GOVERNMENT OF CANADA  
ENVIRONMENTAL ASSESSMENT REVIEW  
ROGERS PASS REVIEW PANEL

REVIEW OF ROGERS PASS TUNNEL VENTILATION SYSTEM CONCEPTS

PROPOSED BY C.P. RAIL

BY KLOHN LEONOFF LTD.  
CONSULTING ENGINEERS  
RICHMOND, B.C.

FIGURE 6A: C.P. RAIL FACT SHEET SIDE 1

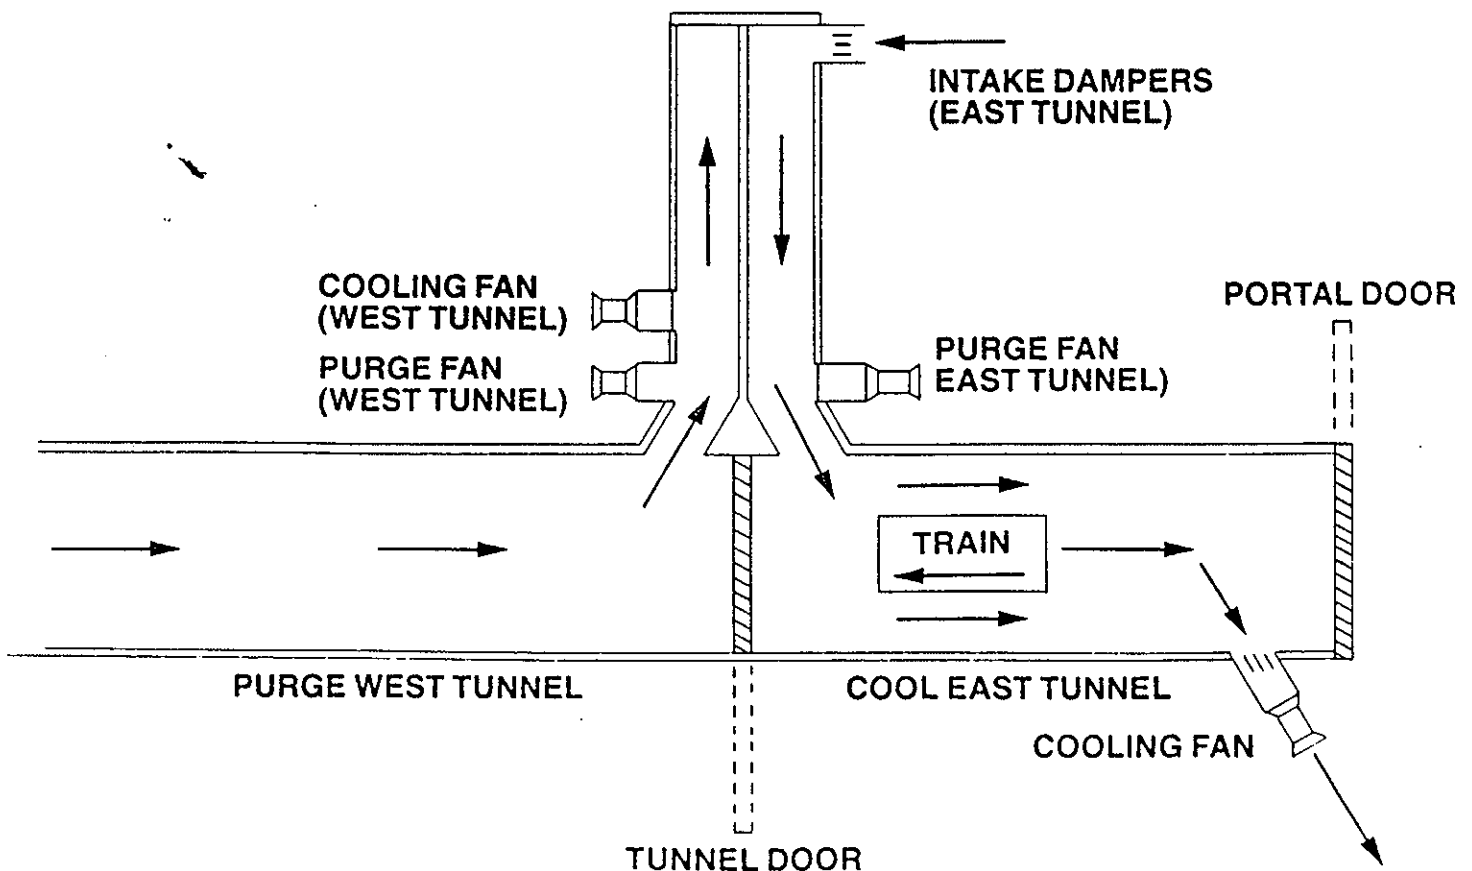
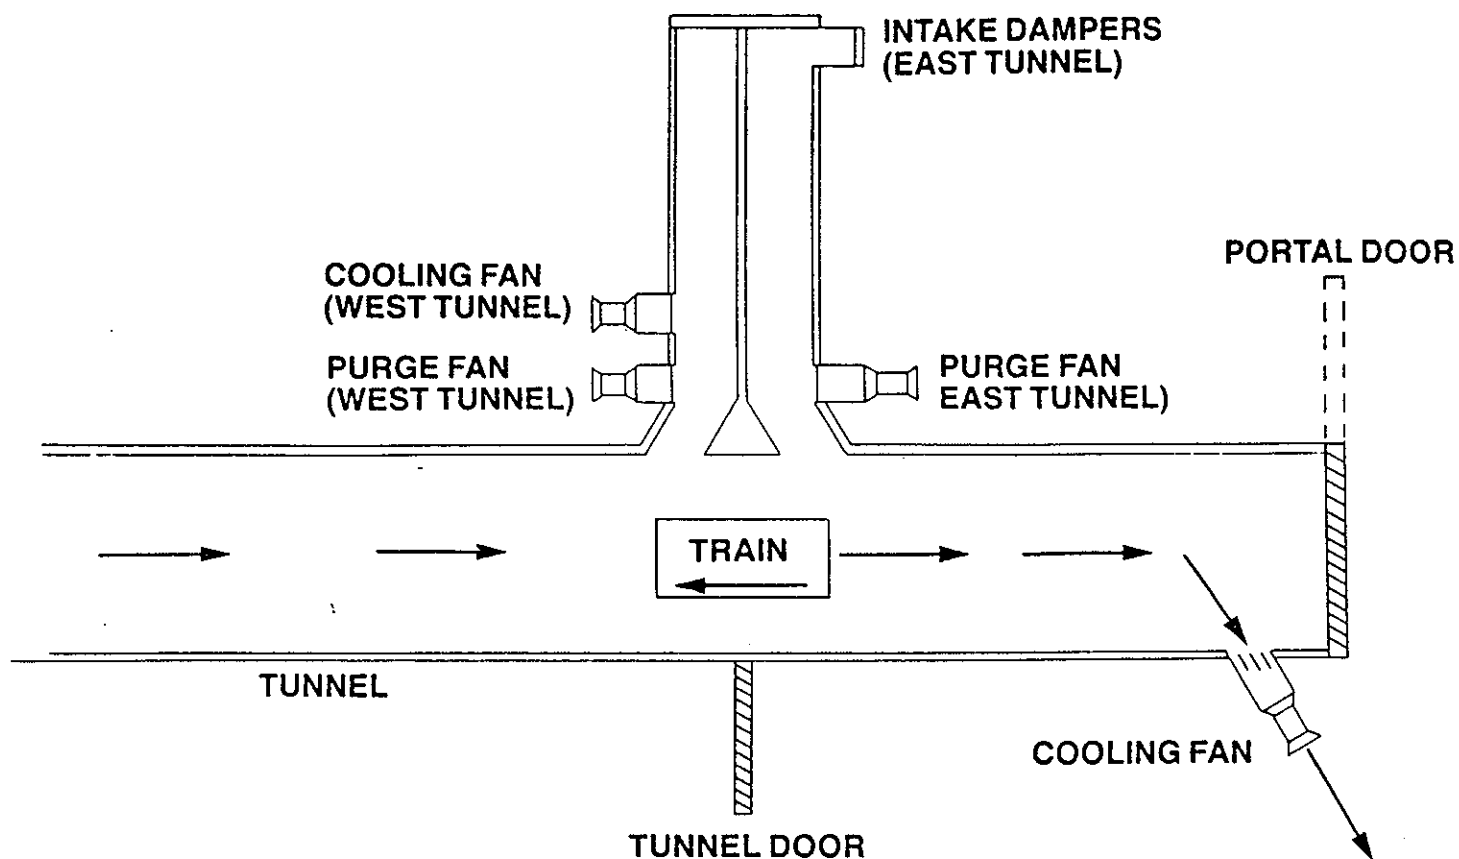
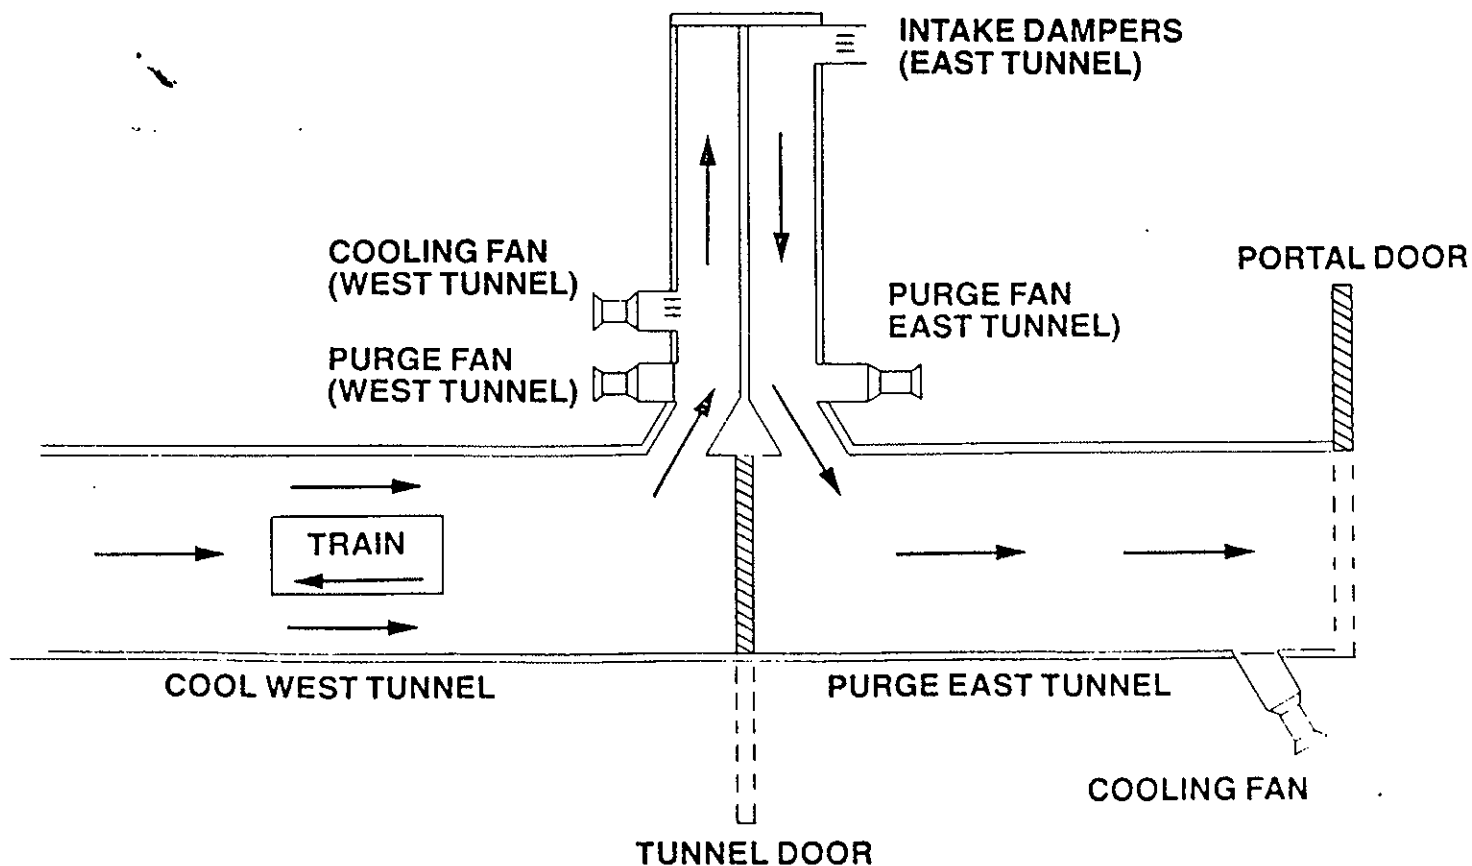
It should be noted that the analyses quoted by PBQD 1980 (1) and 1981 (2) are in terms of fans located at the top of the shaft. However, in discussions with CP Rail and as presented in their "Tunnel Fact Sheet" shown in Figure 6 they plan to locate the fans at the foot of the shaft. This will not materially effect the emissions from the ventilation system although it will reduce the noise at ground level.

<b>KLOHN LEONOFF LTD.</b> CONSULTING ENGINEERS		CPR ROGERS PASS TUNNEL VENTILATION ALTERNATIVE VENTILATIONS SYSTEMS LINKED TO CONNAUGHT TUNNEL	
FEDERAL ENVIRONMENTAL ASSESSMENT REVIEW OFFICE		PROJECT NO. VA2995 DATE OF ISSUE APRIL 12, 1982 APPROVED BY <i>[Signature]</i>	
		FIGURE 7

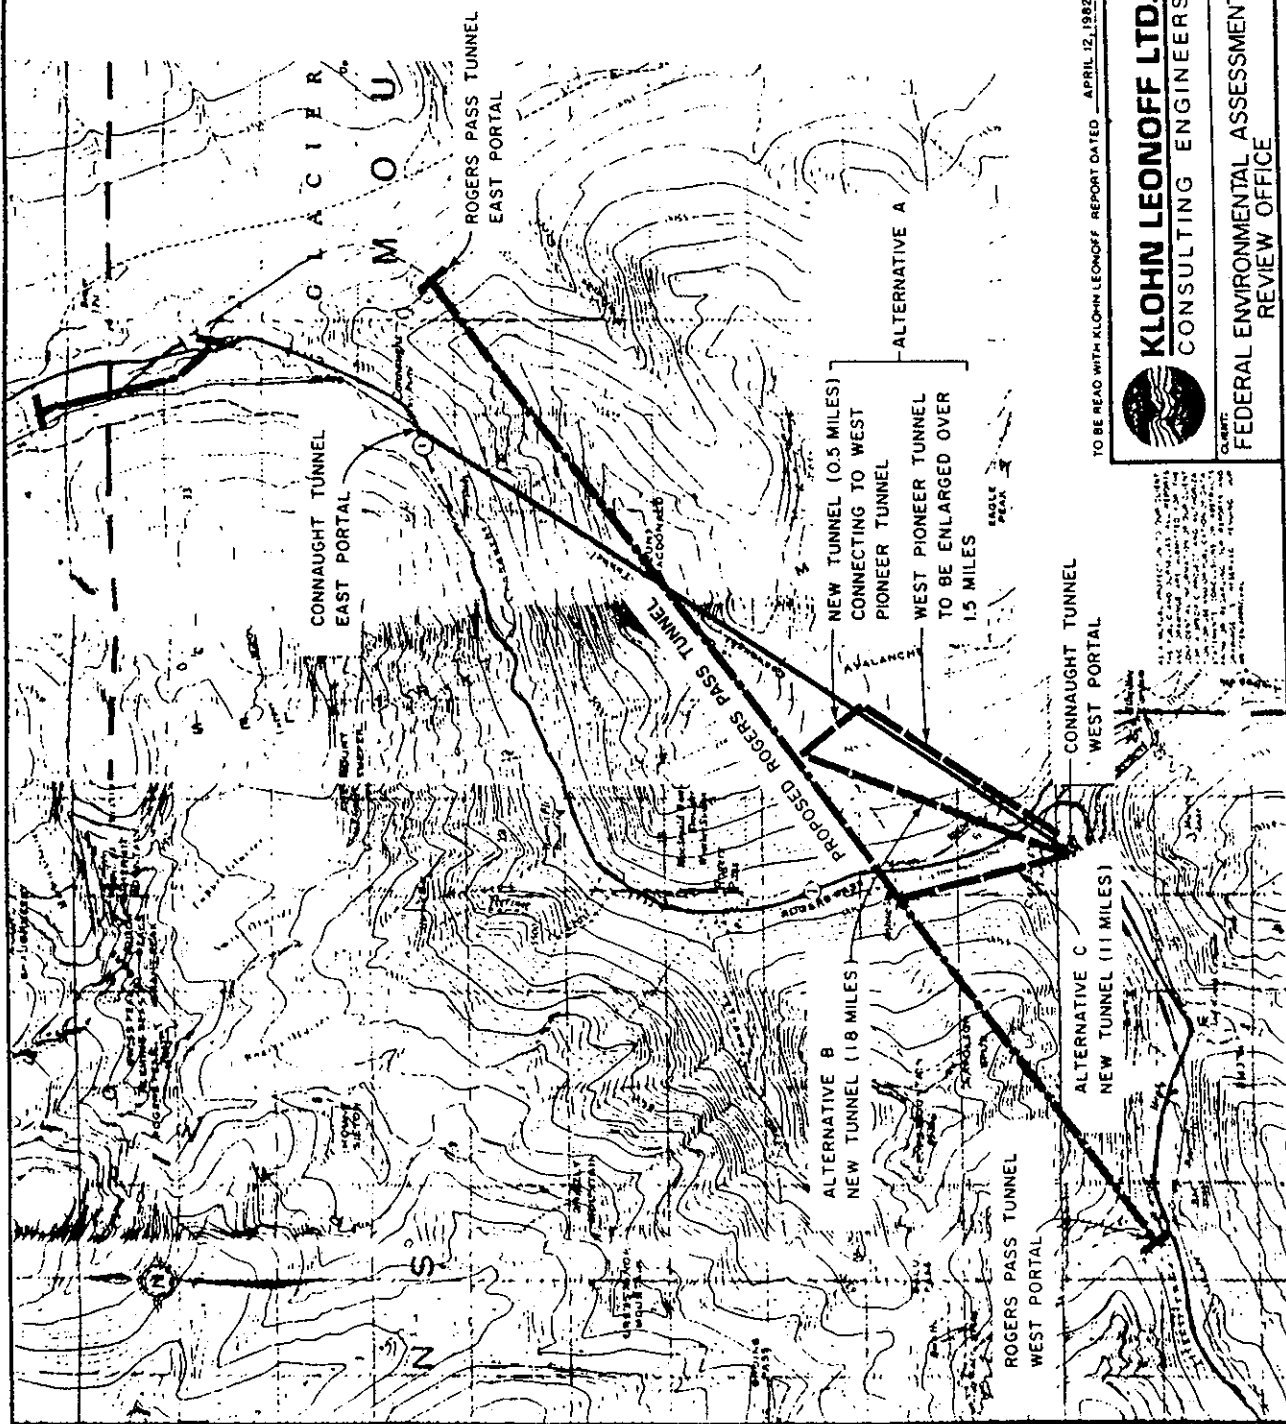
If the PBQD Concept 3 configuration is installed it may still be possible to minimize the exhaust from the shaft by establishing the ventilation system control logic so that normal purging or cooling exhaust is handled via the east portal fans. The operation of the exhaust from the shaft would only be achieved through an automatic control override in the event of traffic queing situations to prevent unnecessary delays. This would not eliminate shaft exhausts but might reduce the shaft exhaust quantities in the short term. It does however, introduce complexities in the railway operations which may incur additional costs.

FIGURE 9

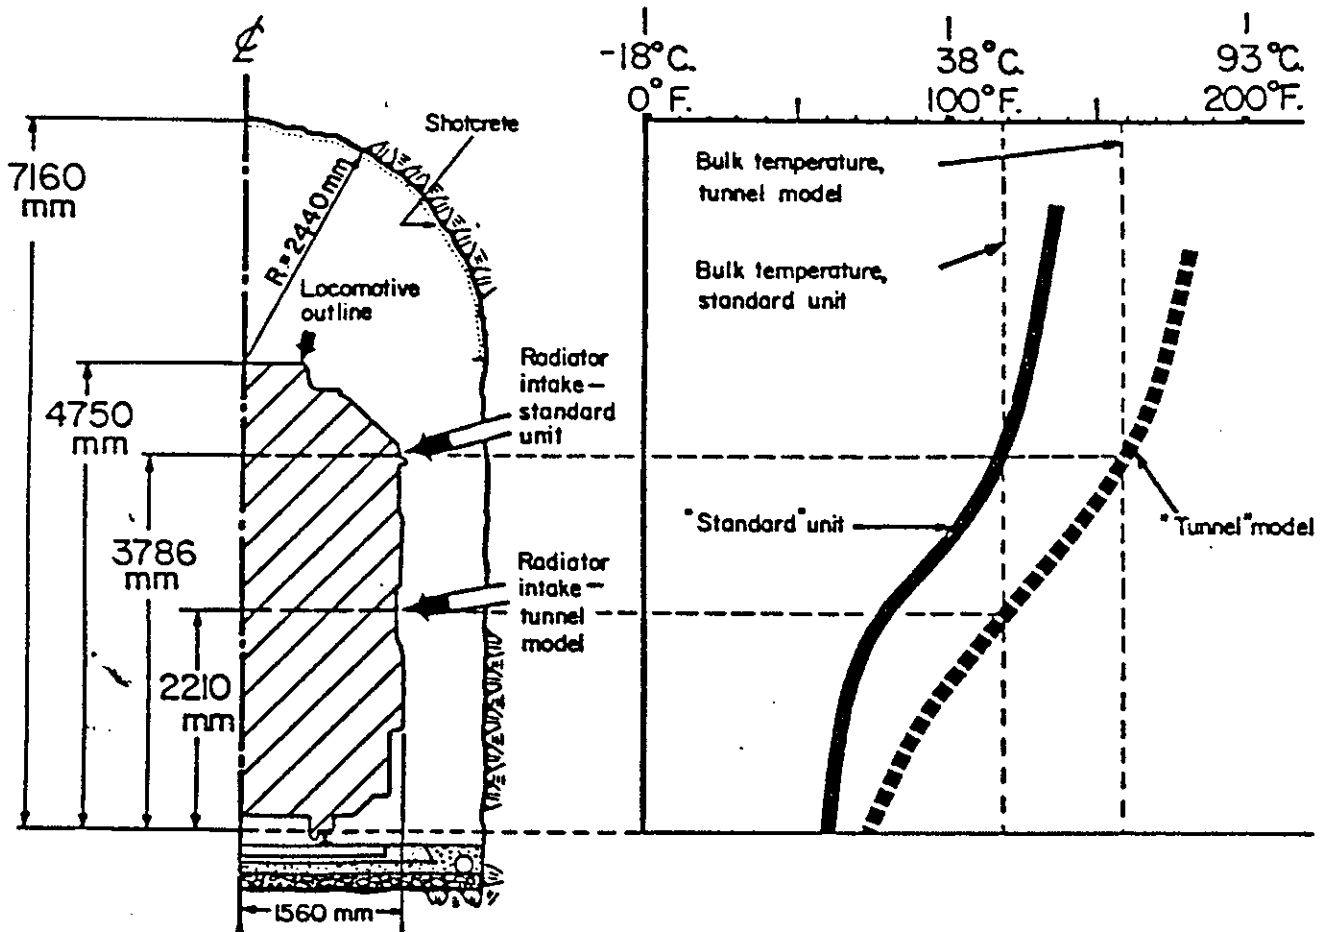
stratification which occurs and the resulting temperatures at air intake locations. This is shown schematically in Figure 9. The calculations are based on an overall heat balance and empirical correlations between observed temperature profiles in tunnels and heat dissipation in the existing American tunnels and certain other analytical models.

<b>KLOHN LEONOFF LTD.</b> CONSULTING ENGINEERS		PROJECT <b>CPR ROGERS PASS TUNNEL VENTILATION</b>
CLIENT <b>FEDERAL ENVIRONMENTAL ASSESSMENT REVIEW OFFICE</b>		TITLE CYCLE DIAGRAM NO. 7 Concept 5 - 15000TT Coal Train
DATE OF ISSUE APR 12, 1982	PROJECT NO. VA 2995	FIGURE NO. FIGURE 10.7

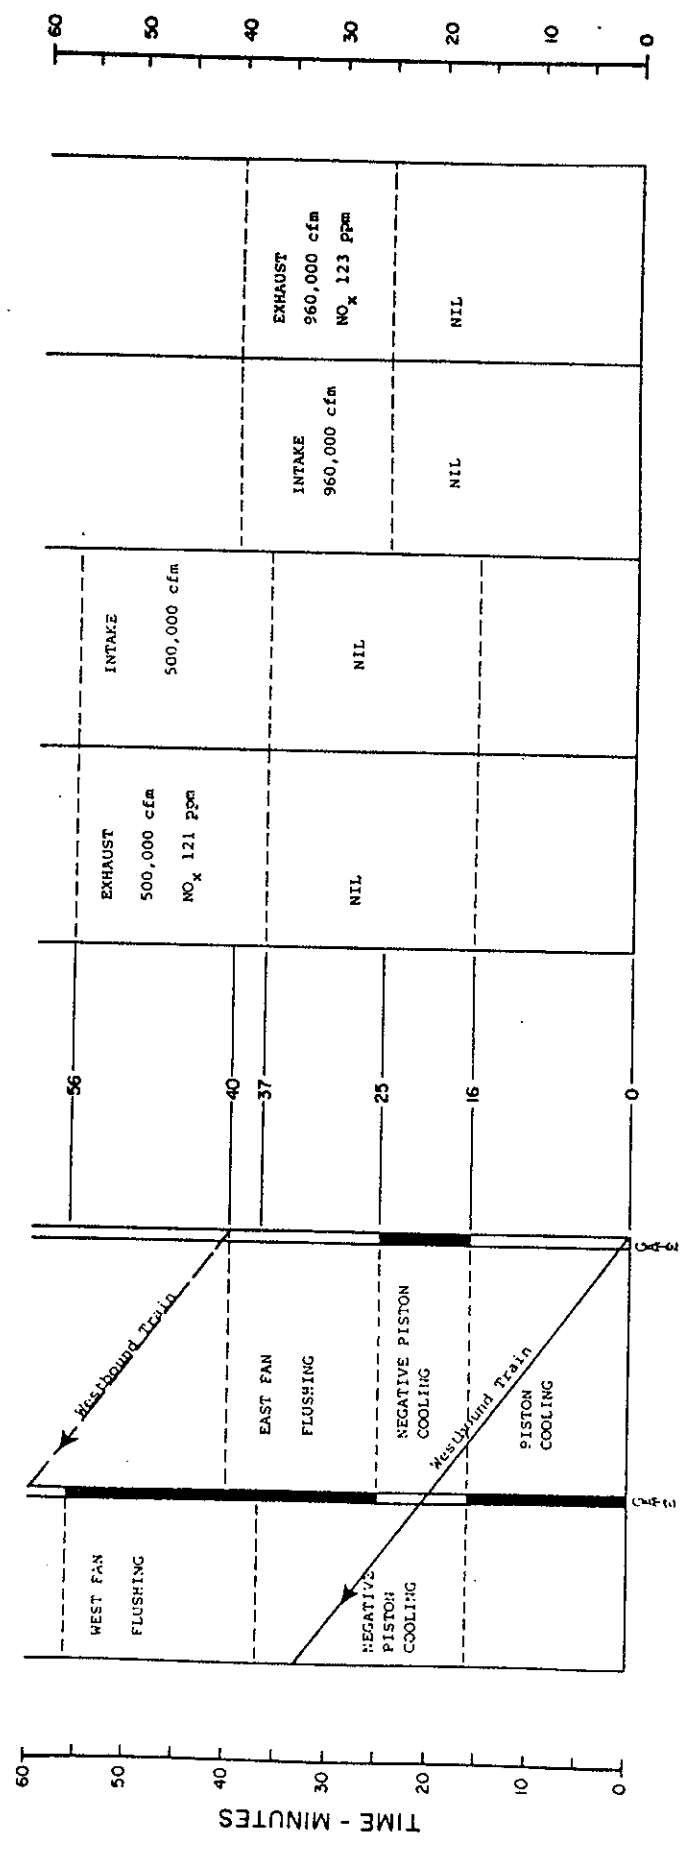
Cycle diagram 7 shows the operation of Concept 5 in which "Tunnel modification" locomotives are used in addition to the purging of the west section of the tunnel through the west portal. In this case there are no emissions through the central shaft.

FIGURE 10.8

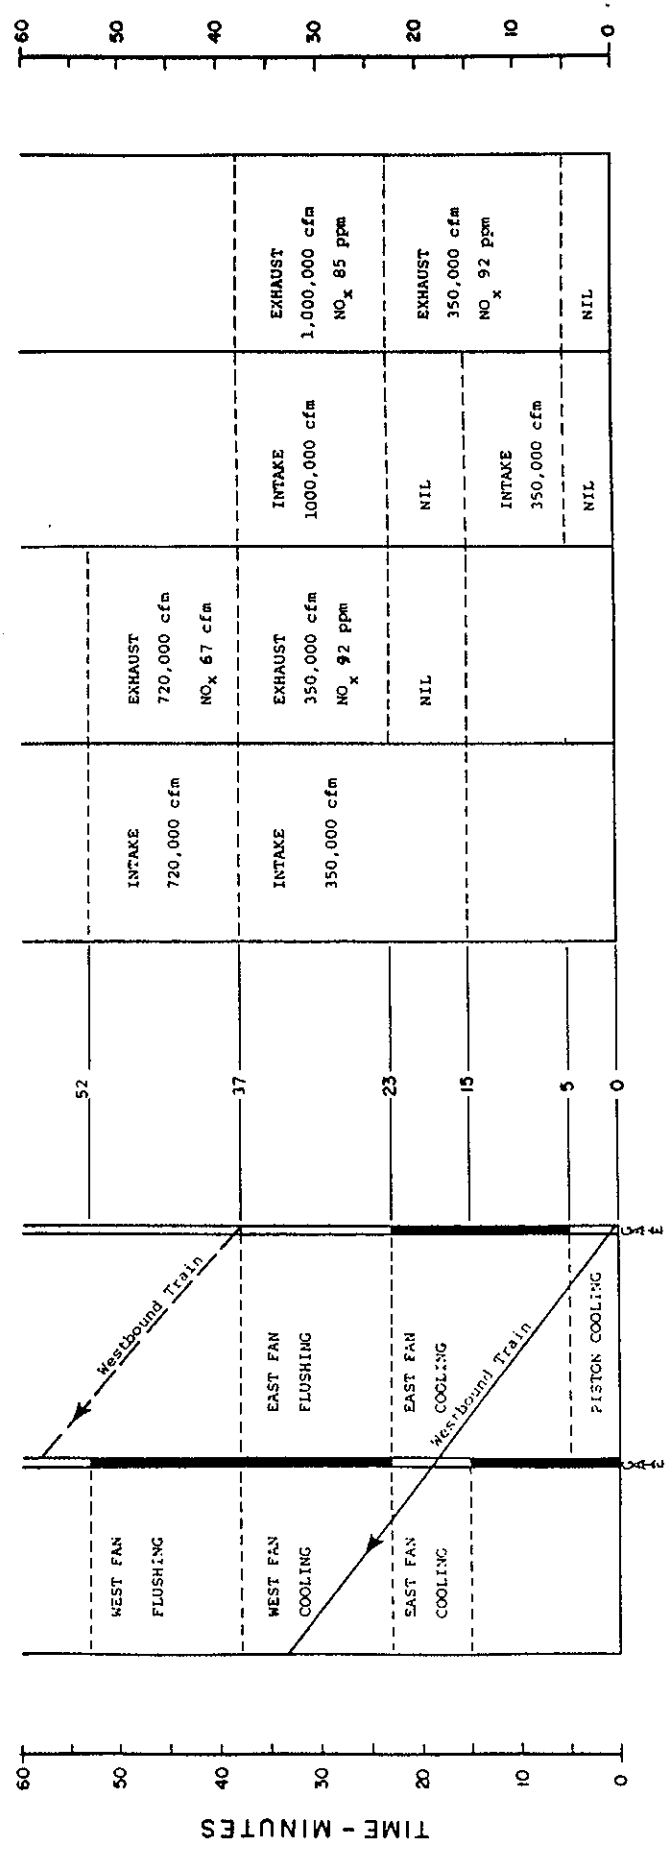
If the shaft is moved to Location 2 on Avalanche Mountain then the cycle time or minimum headway is reduced by approximately 2 minutes to 37 minutes for the heavy coal train as shown in Figure 10.8. The final fan designs will need to be finalized by CP Rail to accommodate the proposed 606 ft long horizontal ventilation adit connecting the tunnel to the shaft.
